Office Action Summary

10/052,626

MATSUSHIMA ET AL.

DETAILED ACTION***Claim Rejections - 35 USC § 103***

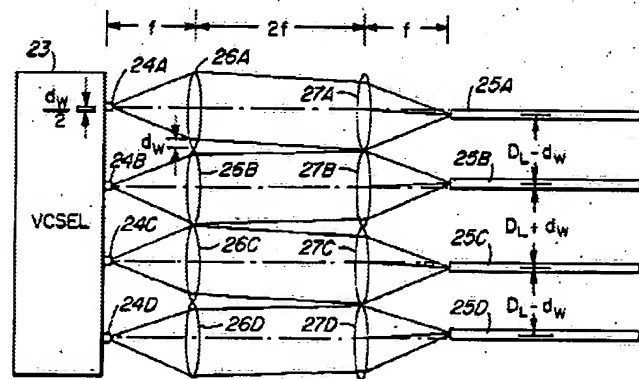
2. **Claims 1-3** are rejected under 35 U.S.C. 103(a) as being unpatentable over Robertson et al (US 5,857,042).

Robertson et al (Robertson hereinafter) show an optical interconnection arrangement comprising:

a light emitting element (23);

an optical fiber (25A);

a first lens (26A) for collimating

light from the light emitting element; and

a second lens (27A) for focusing

said collimated light to said optical fiber;

wherein when a focal length of said first lens is designated by a notation f_1 and a focal length of said second lens is designated by a notation f_2 , said first lens and said second lens are arranged such that an optical distance d between a principal plane of a side of said first lens proximate to said second lens and a principal plane of a side of said second lens proximate to said first lens satisfies $|d - (f_1 + f_2)| \leq 5 \times f_1$.

Although Robertson does not expressly show that relationship of the focal lengths, Robertson shows in Figure 8 that d is approximately equal to $2f$, $f_1 = f$, and $f_2 = f$, therefore:

for claim 1: $|d-(f_1+f_2)| \leq 5 \times f_1$,

for claim 2: $d = f_1 + f_2$,

for claim 3: $|d-(f_1+f_2)| \leq 5 \times f_1$.
